**Planning Department
Transportation Development Services**

**Re: Applebee's, 98th St.
Traffic Circulation Layout**
Engineer's/Architect's Stamp dated 4-08-15 (K09-D038)

Traffic Circulation Layout

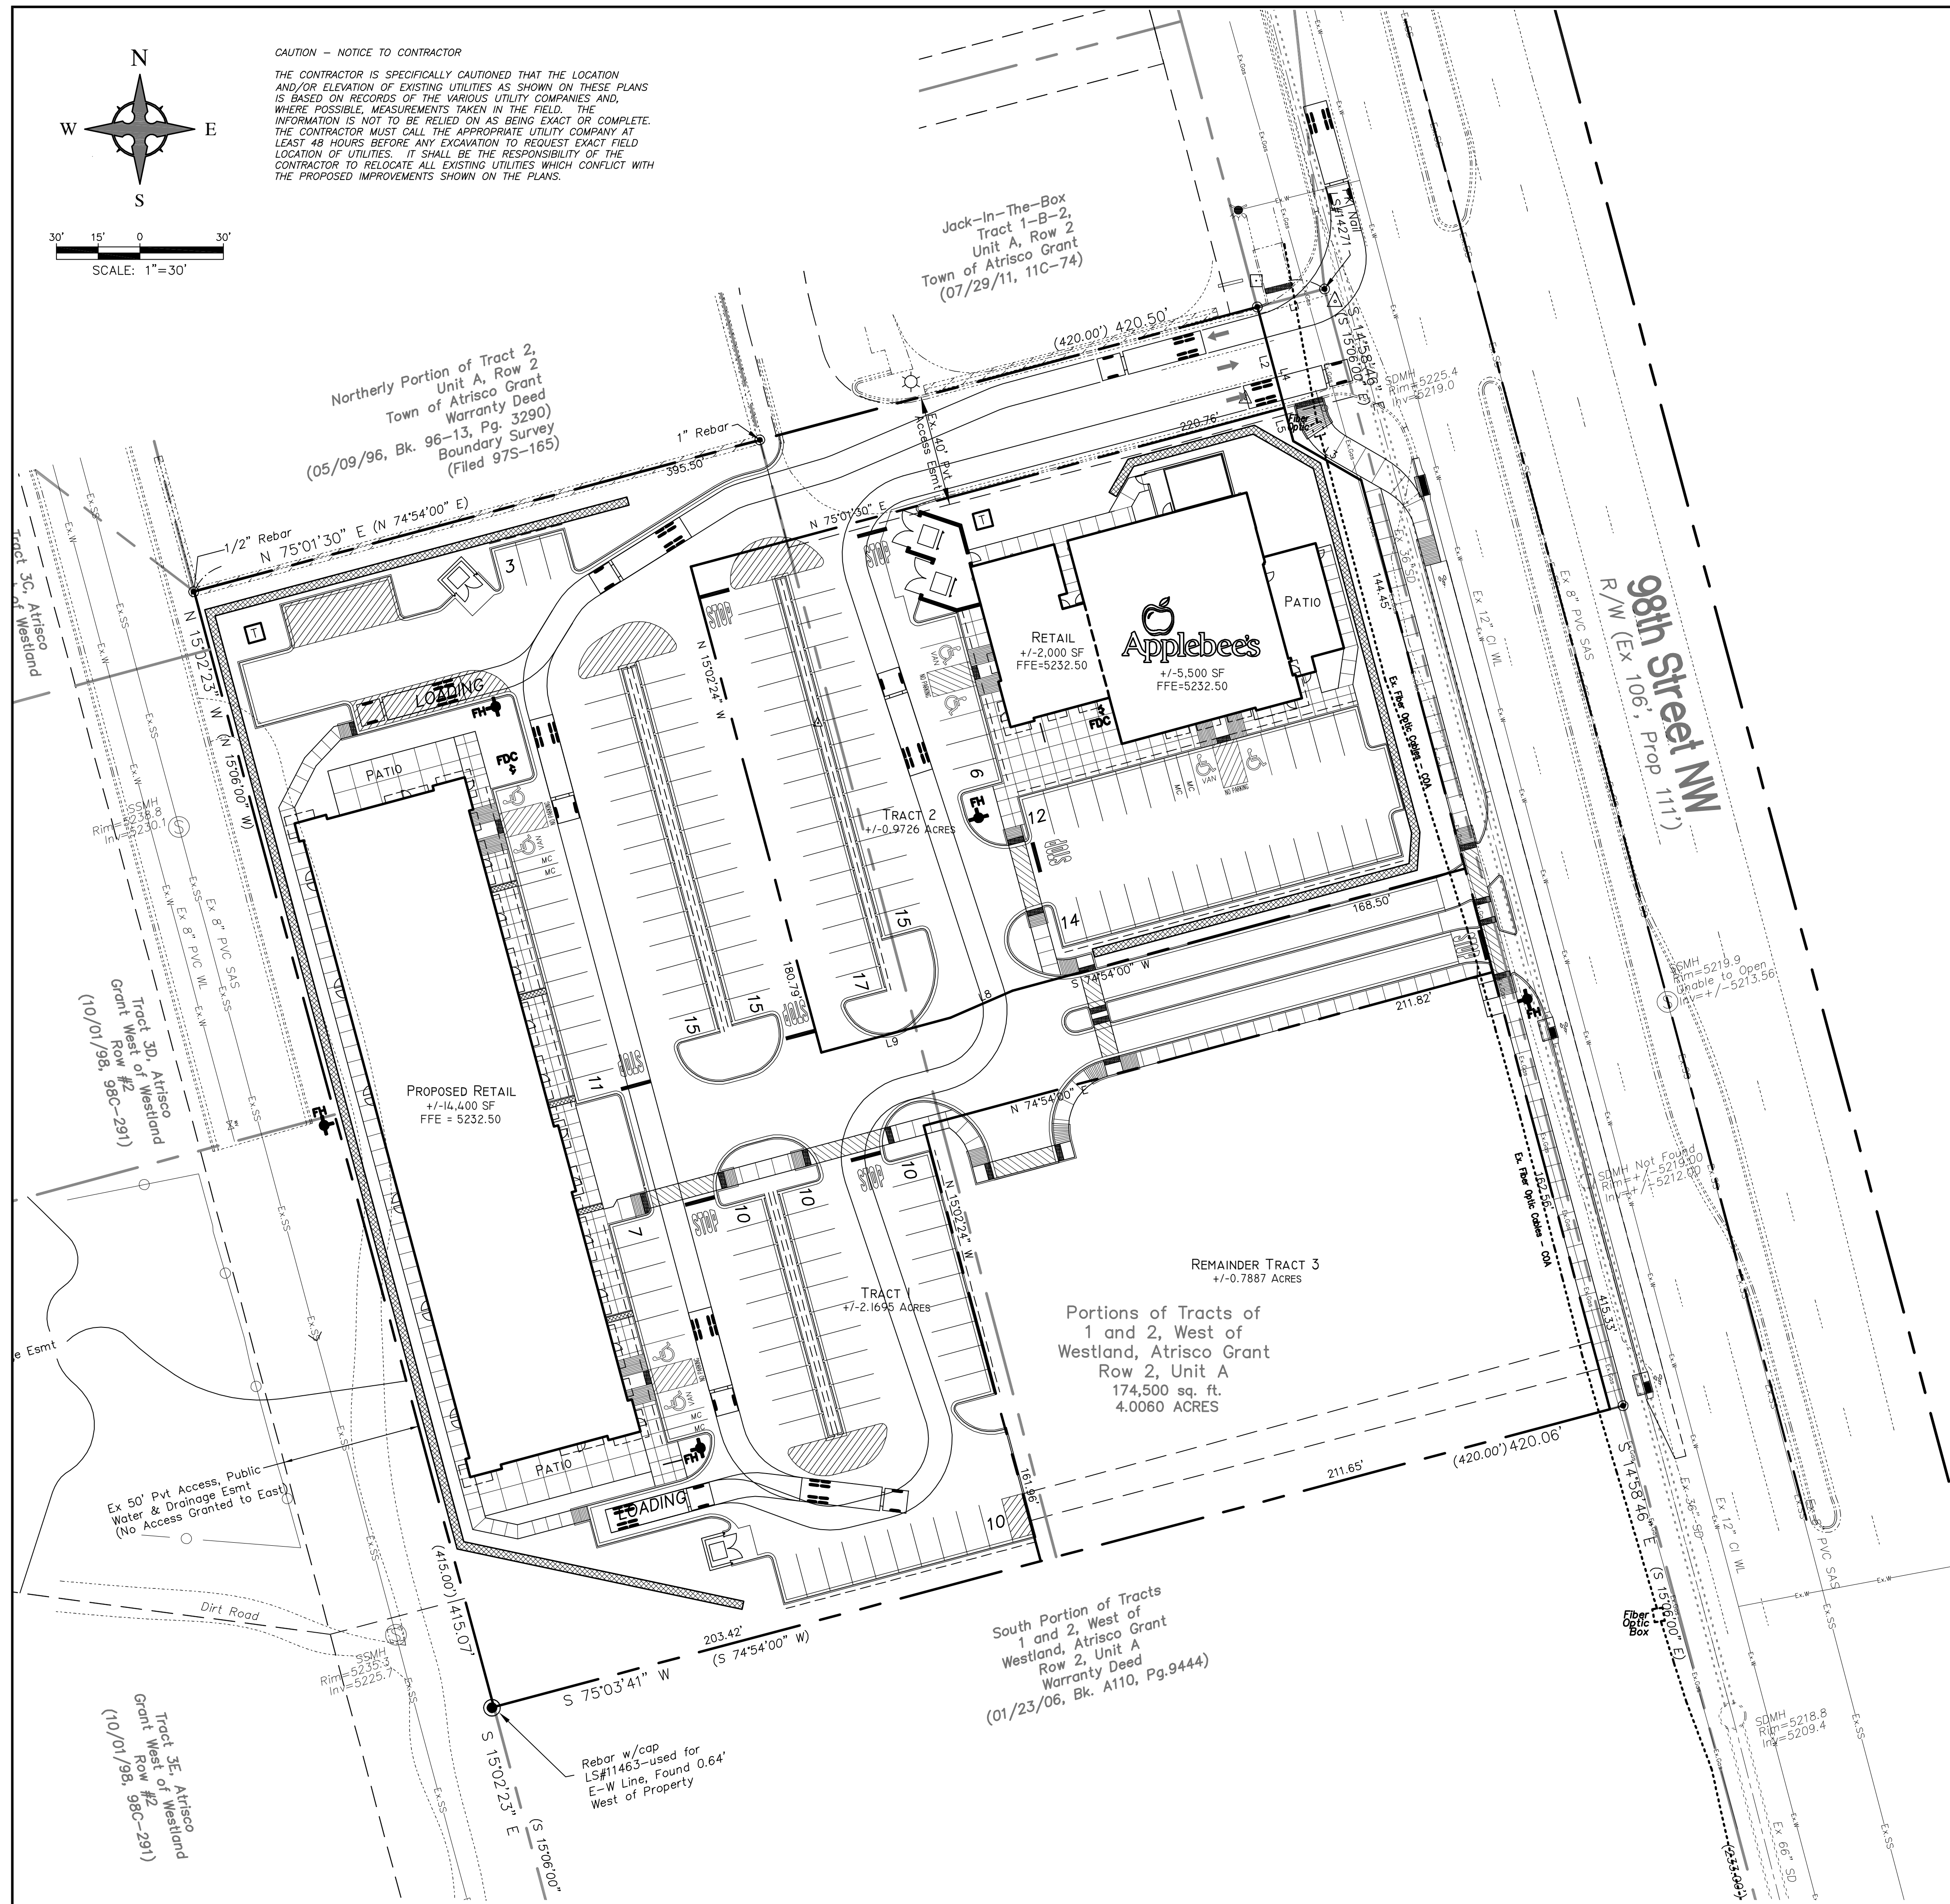
The TCL submittal received 04-09-15 is approved for Building Permit. A copy of the stamped and signed plan will be needed for each of the building permit plans. Please keep the original to be used for certification of the site for final C.O. for Transportation.
